2020-03-23

States notifying them of this safety-related condition and instructing them to contact their dealer for inspection and service. A sample of the customer letter is attached. Harley-Davidson Canada will send a letter to registered owners of affected product in Canada. Other customers outside the United States may receive this notification by other means.

Figure 1. Vent Baffle

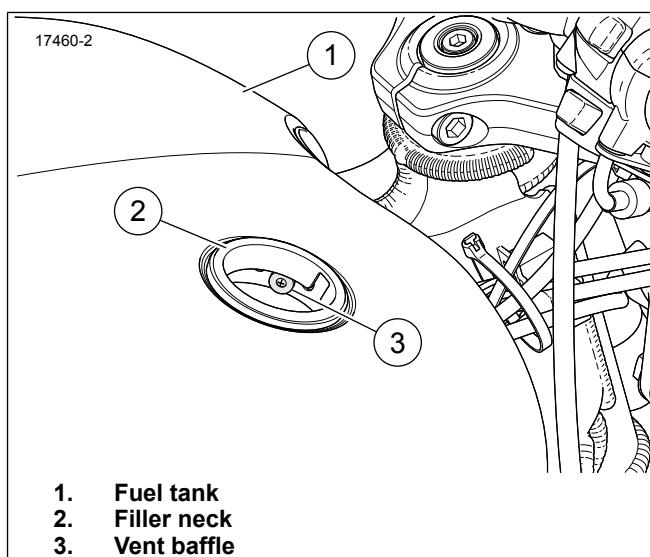
When removing and installing the vent baffle, cover fuel tank inlet to prevent vent baffle from falling into fuel tank.

4. See Figure 1. Remove the vent baffle (3) from the filler neck (2).
5. Install the **new** vent baffle.
6. Install the fuel tank cap.

Figure 2. Fuel Pump - 61200001A

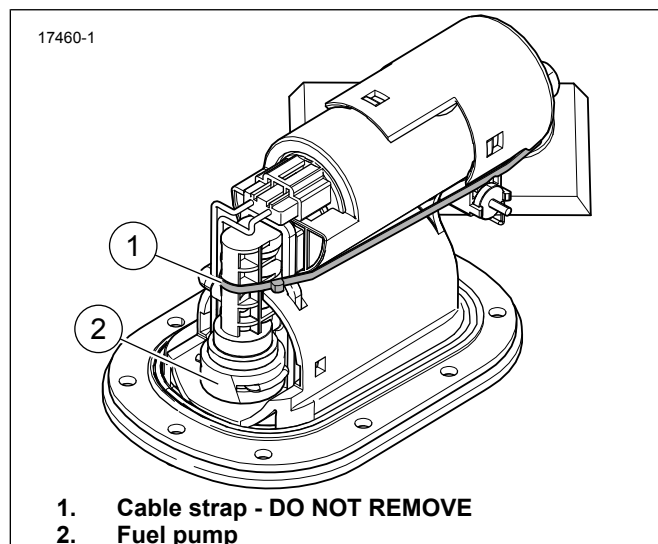
- See Figure 2. **61200001A**: This fuel pump is designed with a cable strap (1) installed on the pump, do not remove.

Figure 3. Fuel Pump - 61200001B

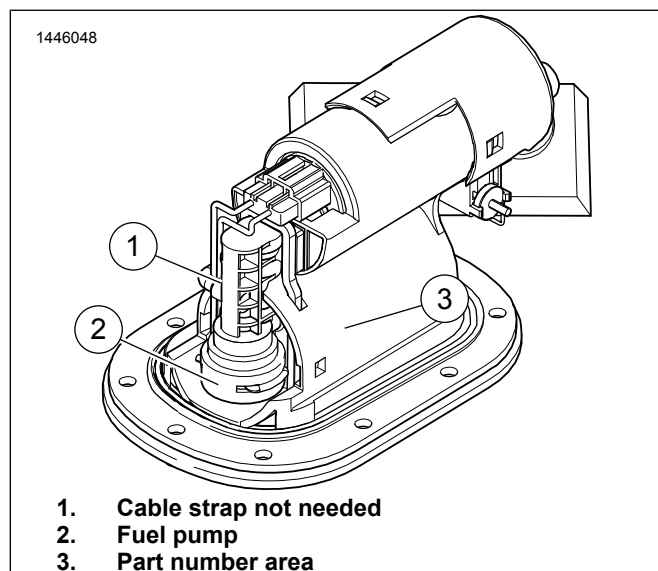
- See Figure 3. **61200001B**: This fuel pump is designed without a cable strap (1) installed on the pump, cable strap is not need. The part number is etched (3) on updated fuel pump.
